Reference No: PPA/2021/0010

Address: Car Park and open land to the rear of Kerswell Close and 162 St Ann's Road, London, N15 5HT

Proposal: Demolition of existing retail unit and removal of existing car park and erection of a part 4, part 5 storey building plus a separate dwelling house comprising 26 new affordable homes for Council rent together with associated amenity space, two car parking spaces, secure cycle and refuse storage, landscaping, tree planting and other public realm works.

Report of Formal Review Meeting: Kerswell Close

Fig 4: Tree planting plan

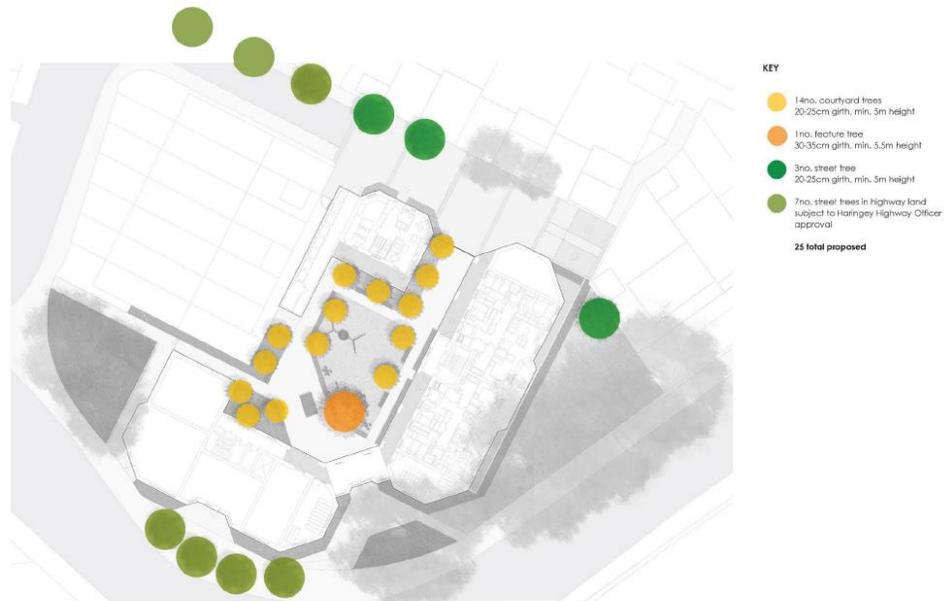
- 7.15. The loss of one of the large trees fronting Seven Sisters Road will be necessary to accommodate the development and was also considered acceptable in the previous application for the site. The loss of 21 trees will be compensated for by

the provision of 25 new trees on and around the site. It is anticipated that the replacement of parts of this poor quality green landscaped area with a new high-quality development featuring widened footways and comprehensive new planting, as well as active frontages, would provide significant visual amenity and security benefits to the local area.
